SERVICE INSTRUCTION **XK-SI001** Rev NC Page 1 of 7

SUBJECT: *COWL FITMENT WEAR PREVENTION*

MODELS AFFECTED: *CCX-2300 S/N 0001 THROUGH 0015*

PURPOSE: *This document provides instructions for the inspection and modification of the engine cowling and baffling to prevent excessive wear and improve fastener and/or component clearance.*

Figure 3 - Upper Cowl Possible Chafing Locations

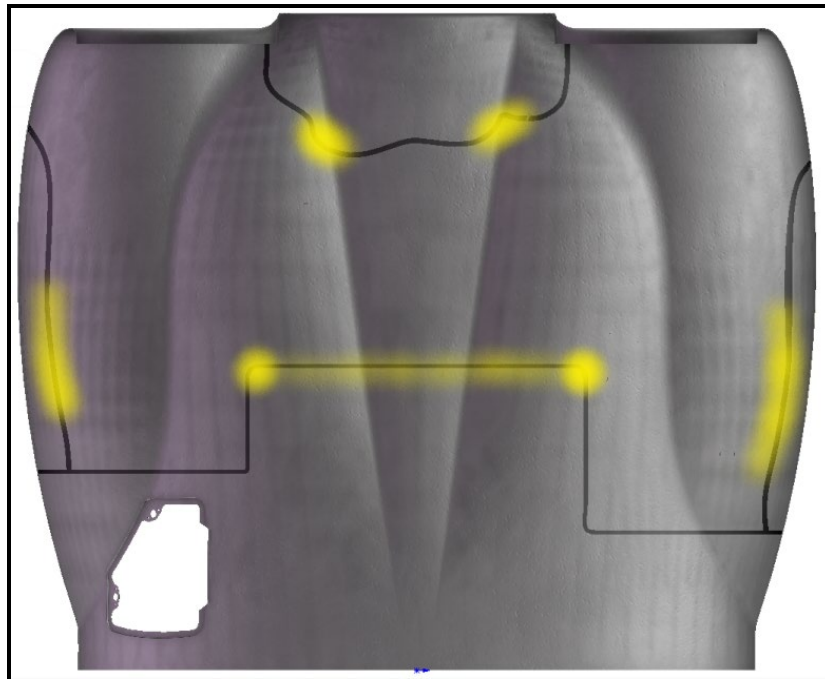
4. *Steps 5-9 are each subject to inspection results and the discretion of the owner/operator. Some, all, or none of the zones described may exhibit wear from inadvertent component contact. If no signs of excess wear are present on any cowl panels, proceed directly to Step 10.*
5. Locate and mark all zones where direct composite to composite or fastener to composite contact is in evidence. Figure 3 depicts possible contact zones on underside of the upper cowl.

Figure 4 - Possible Baffle Zones in Contact with Upper Cowl

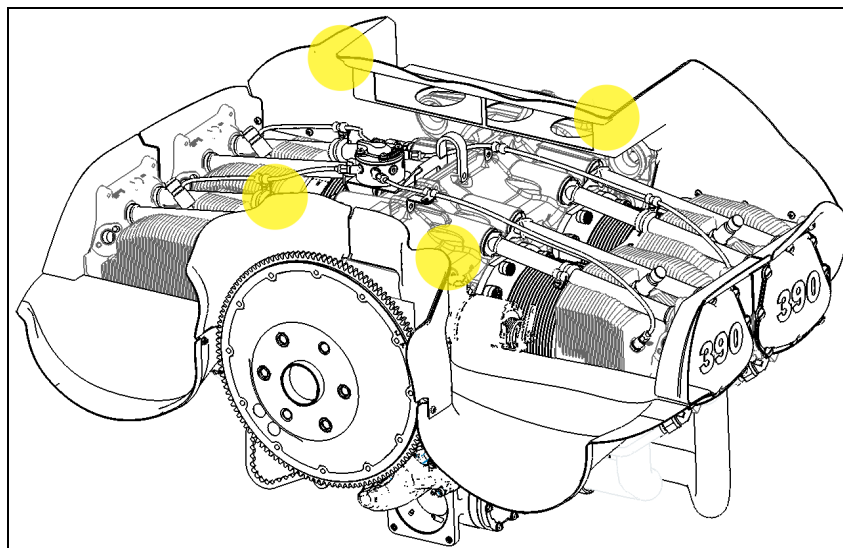
6. Using upper and lower cowling marked zones as a guide, locate corresponding possible causes of wear on **composite** baffle components. See possible zones highlighted in Figure 4. Zones where baffle composite is in occasional contact with the engine cowling may be trimmed by filing, sanding, or using a rotary tool. Edges of baffles may be trimmed as long as 2D edge distance to all fasteners (1/4" from center of hole to nearest edge) is maintained and a minimum of 3/8" overlap is retained between composite engine baffles and the attached baffle seal. Excessive trimming will result in baffle seal leaks that will reduce powerplant cooling performance.

Figure 5 - Possible Lower Cowl Chafing Locations

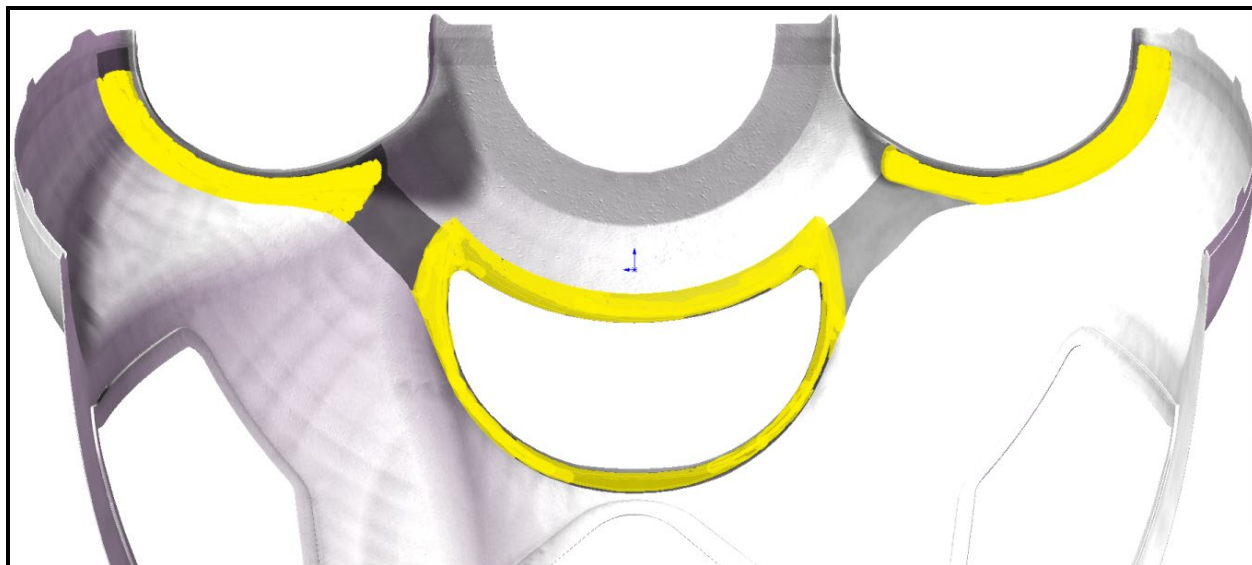
- c. Install and pull replacement rivets with the tail in the down/out direction.
9. Locate zones of lower cowl that have evidence of chafe from inlet baffles and apply protective film tape. See Figure 5 for possible location guidance.

- a. Carefully clean entire area with a solvent such as Acryli-Clean DX-330/SX-330, or rubbing alcohol.
- b. Apply 3M 111 Adhesive Promoter to entire area of tape application
- c. Apply RM1072-001 in 3-4" strips. Longer strips may be difficult to conform to cowl curvature and be more prone to peeling. See Figure 6. "Burnish" tape on with a rounded tool to achieve maximum adhesion.

Figure 7 - Baffle-Seal-Cowl Interface

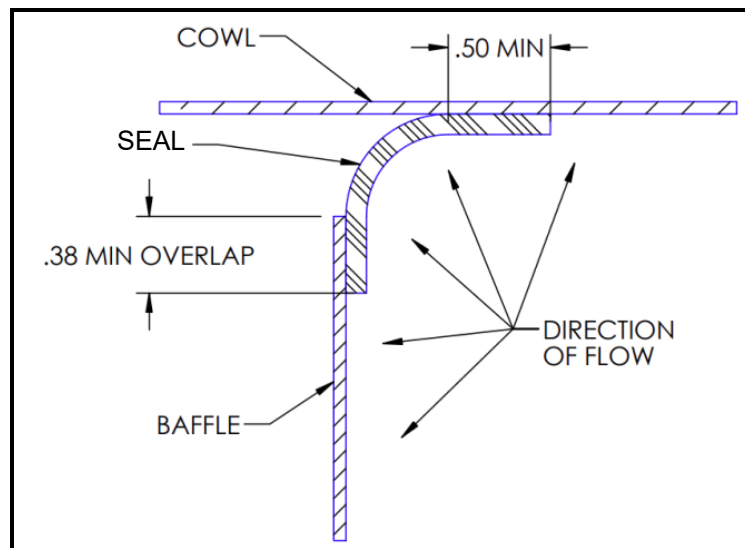
- g. Reinstall upper cowl. Take extra precaution to avoid propeller spinner backing plate fasteners as chipping of the composite cowl may occur.
- h. Ensure all baffle seal overlaps are in the appropriate direction. All seal sections should be flexed up and in toward the center of the upper air plenum
